CITY OF WEST LAKE HILLS, TEXAS
NOTICE OF ZONING & PLANNING COMMISSION (ZAPCO) REGULAR MEETING
Wednesday, May 20, 2020 at 6:30 PM

CITY OF WEST LAKE HILLS, TEXAS
MINUTES OF A ZONING & PLANNING COMMISSION (ZAPCO) REGULAR MEETING
Wednesday, April 15, 2020 at 6:30 PM

B/ NON ILLUMINATED WALL SIGN (EAST ELEVATION)

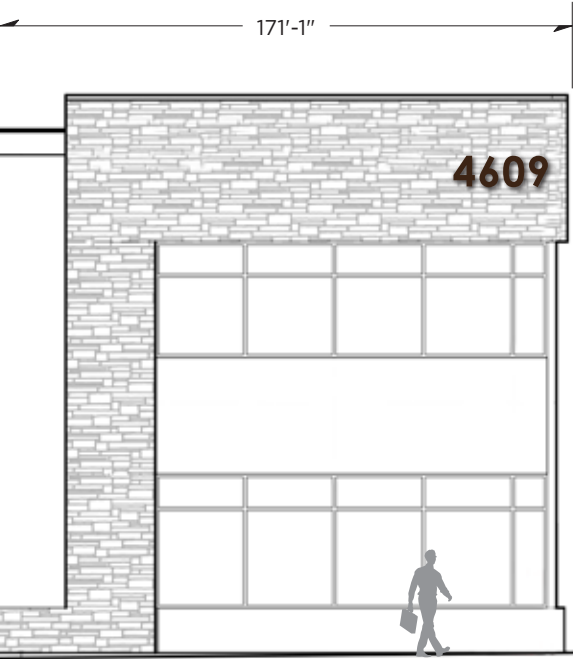
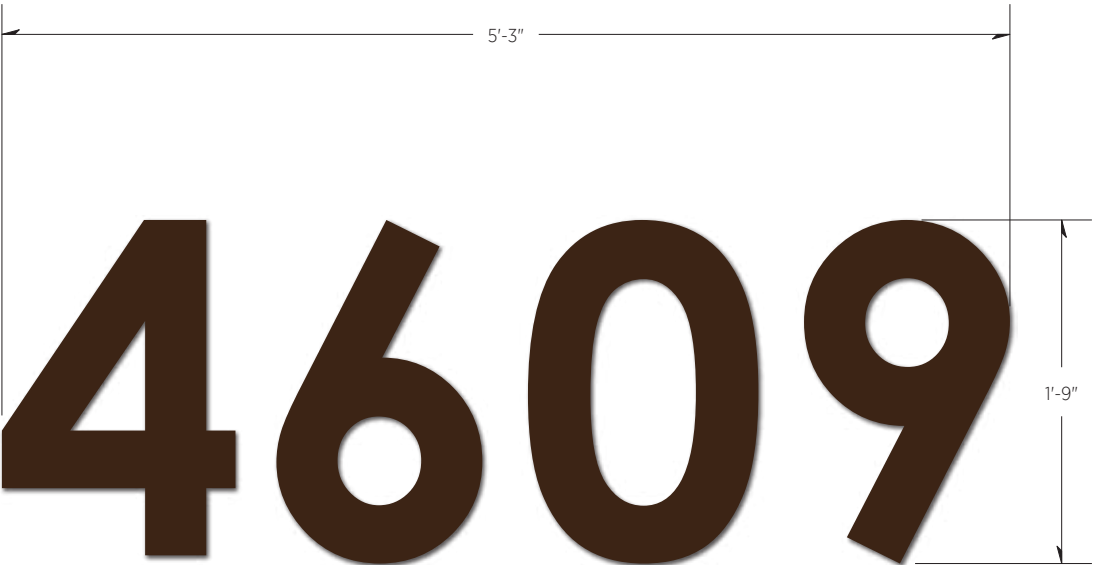
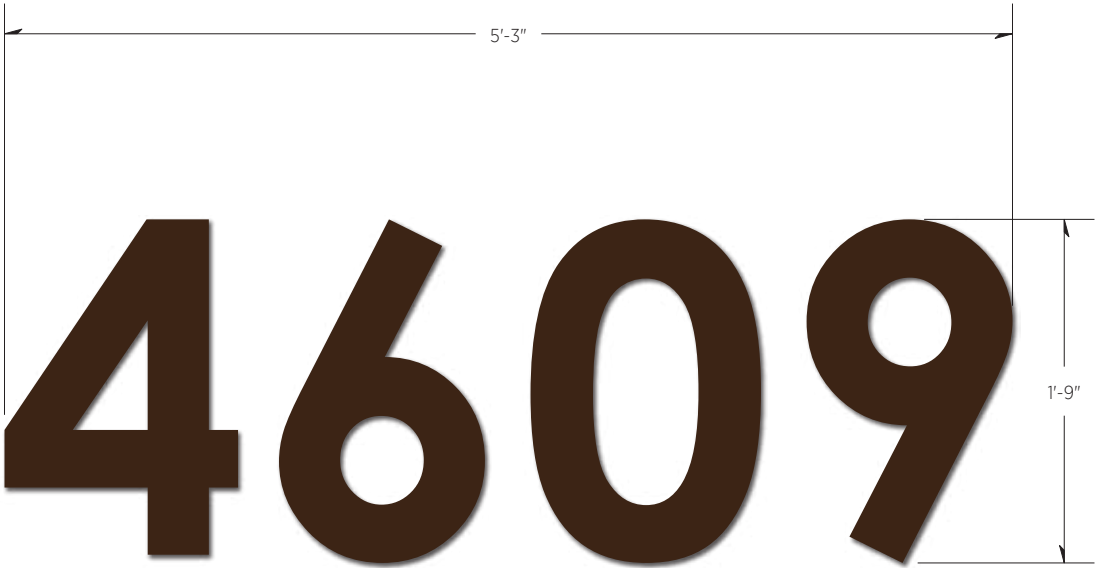
- 1) Purpose. To identify the numerical street address of a multitenant shopping or office complex. | **Complies**
- 2) Size. A maximum of four numbers, and each number with a vertical dimension of no greater than 24 inches and a horizontal dimension of no greater than 12 inches. | **Please provide dimensions of individual numerals**

- 3) Height. No part of the numbers shall extend above the roof line of the building. | **Complies**
- 4) Number. One set of numbers facing the westbound lane of Bee Cave Road or Loop 360 and one set of numbers facing the east lane of Bee Cave Road or Loop 360. | **Site plan showing locations provided and locations appear to meet requirements.**

- 5) Location. On the building complex at the corner of the complex closest to the street. | **See comment above.**
- 6) Design. The sign shall contain only the number of the street address (e.g., 3415). | **Please verify if sign will have shiny or matte/brushed finish (See Code Sec. 38.01.013). Otherwise design complies.**
